**SUBJECT: Invitation for Bids (IFB) 7-1904
"OC Streetcar Construction Project"**

This letter and its Attachments comprise **Addendum No. 6** to the above captioned Invitation for Bids issued by the Orange County Transportation Authority ("Authority").

LN12

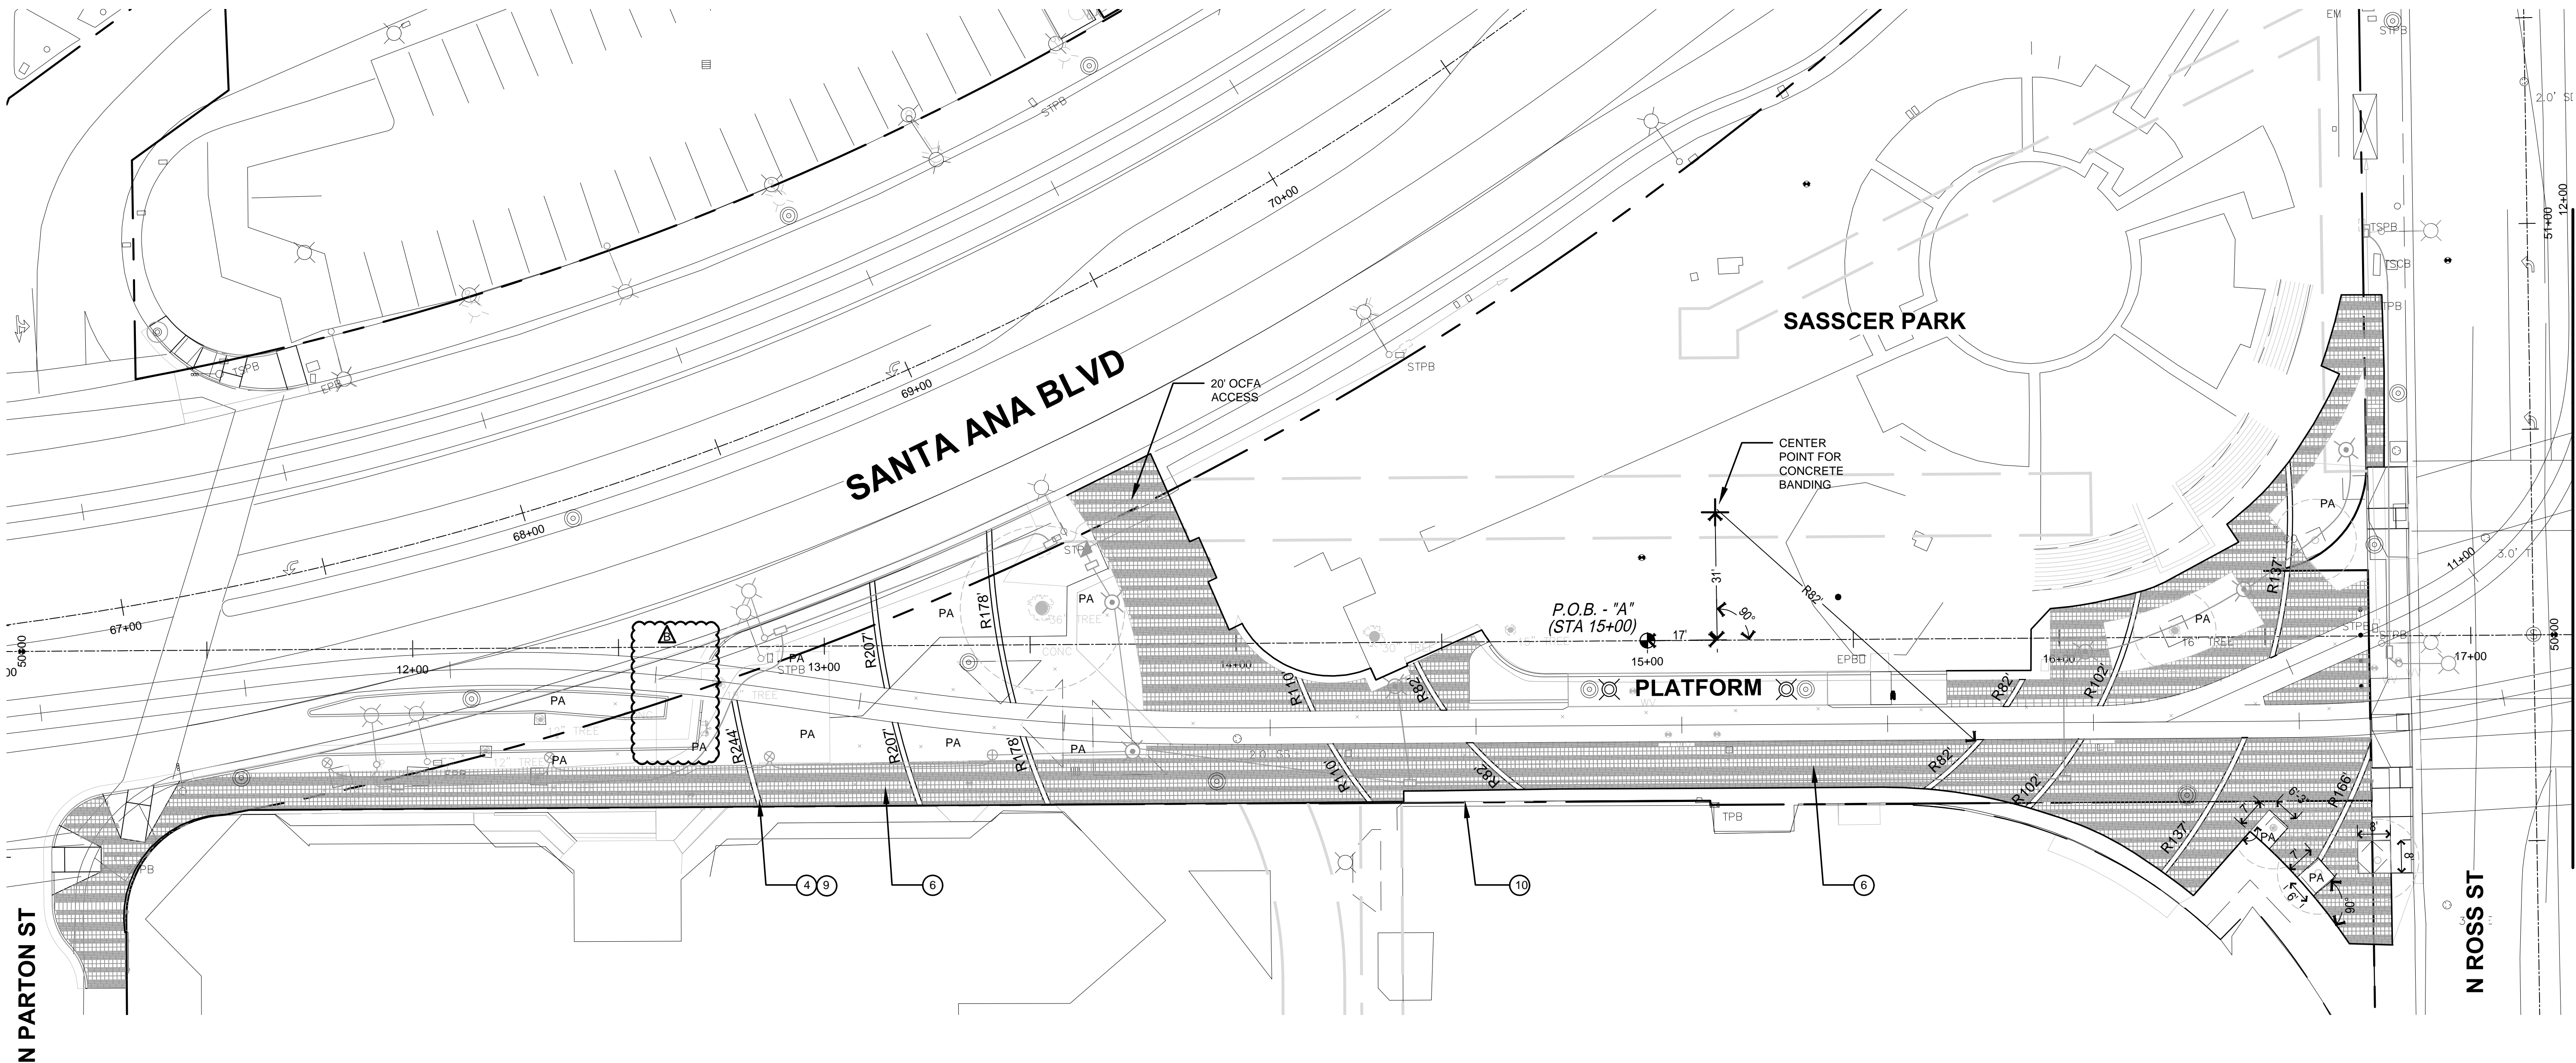
REVISIONS					
NUMBER	DATE	INITIALS	DESCRIPTION	APPROVED	INSTALLED
A	12/2017		ISSUE FOR BID		
Δ	2/22/2018	RW	CPUC - Bike Lane at Sasscer Park

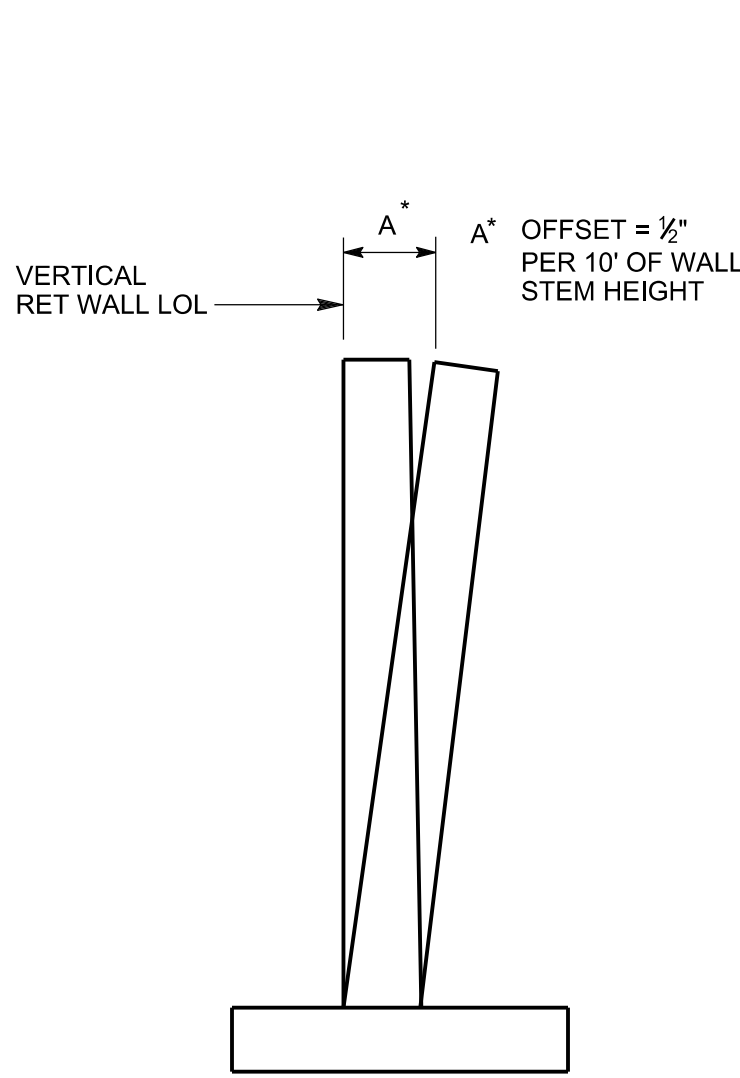
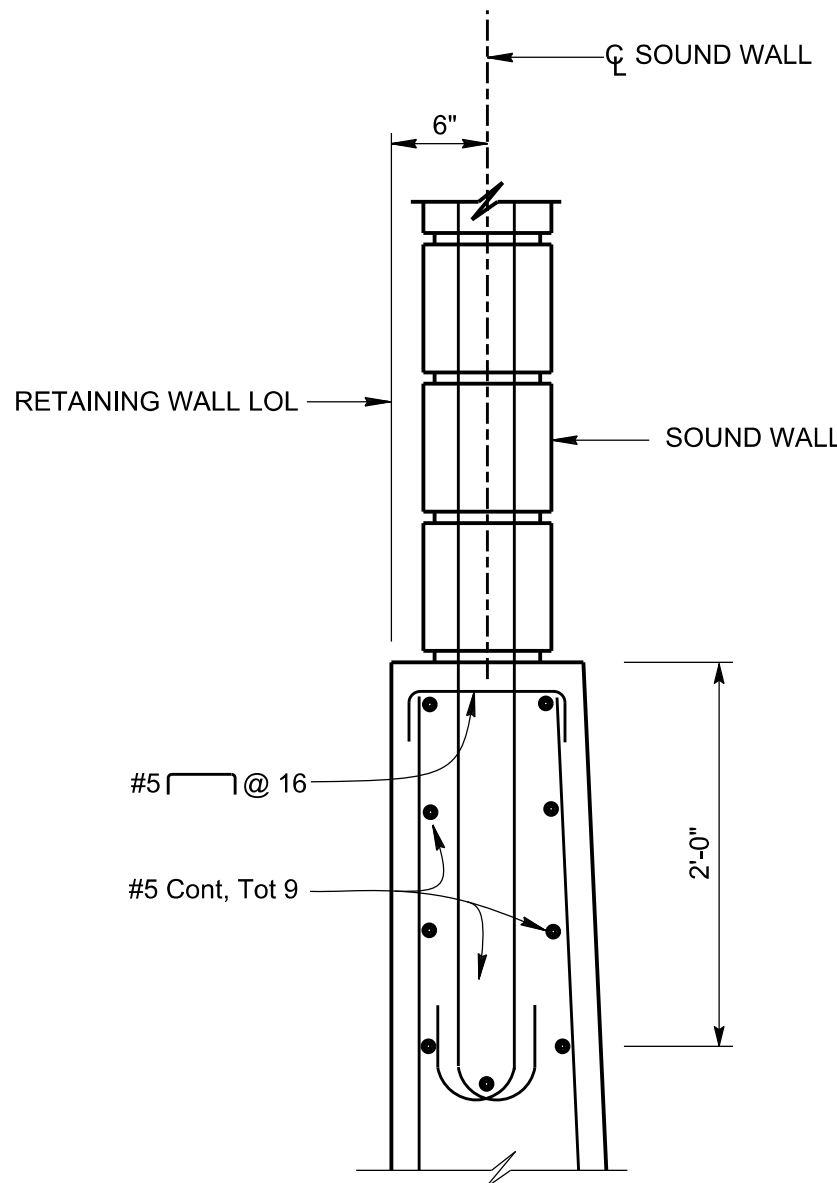
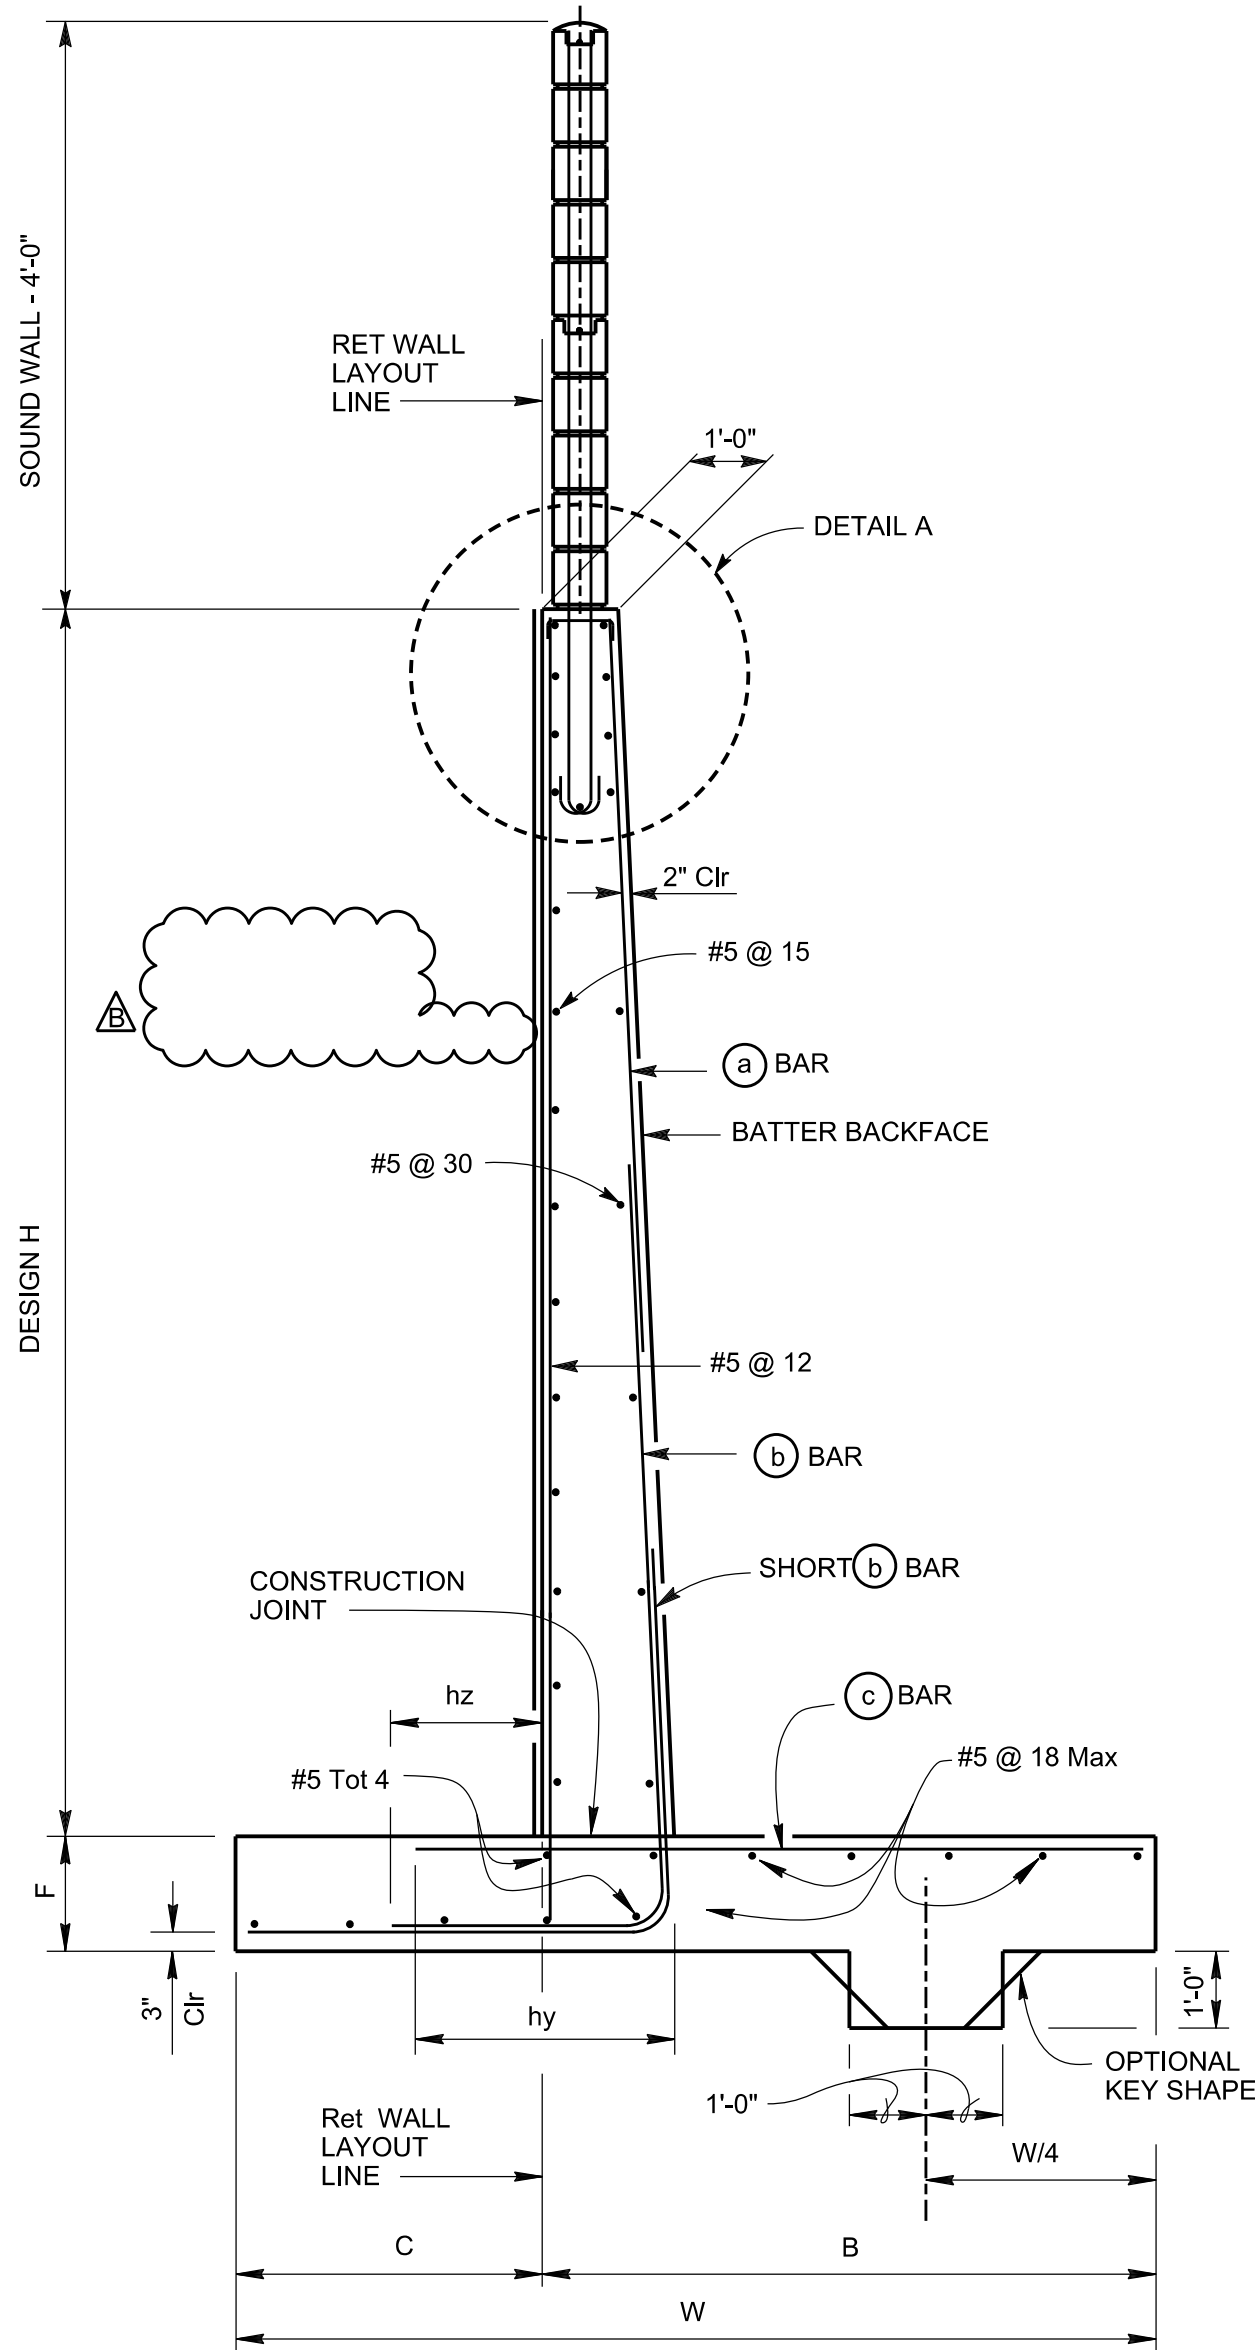
101		ND01, Sheet 694			Sheet 694, Retaining Wall Detail Drawing, Note #1 at the top of the page states "For Sound Wall and Retaining Wall Architectural Finish or Texture See Details Elsewhere in Project Plans." We have been unable to find where any Architectural treatments or textures are being called out in the Plans or Specifications, aside from Anti Graffiti coatings. Please confirm if there are any architectural requirements, coatings or anti-graffiti coatings and provide the details if required.	No architectural treatments or textures are required. Note #1 on ND01 has been revised accordingly in Addendum No. 6.
102	34 11 33, & 34 72 00	TD12, TD13, &TD24			The referenced trackwork specifications do not provide the required spacing for Ties. The referenced drawings show spacings for specific conditions. Is the typical spacing for Ties to be 30"? Is this spacing to be reduced in curves? If so, to what and at what Radius?	Concrete tie spacing is provided in Spec 34 11 33, Section 1.01.C.2.a thru d. Note the following revisions to the referenced spec have been made in Addendum No. 6: c. Grade Crossing Track: 20 inches d. Special Trackwork: As shown on Contract Plans
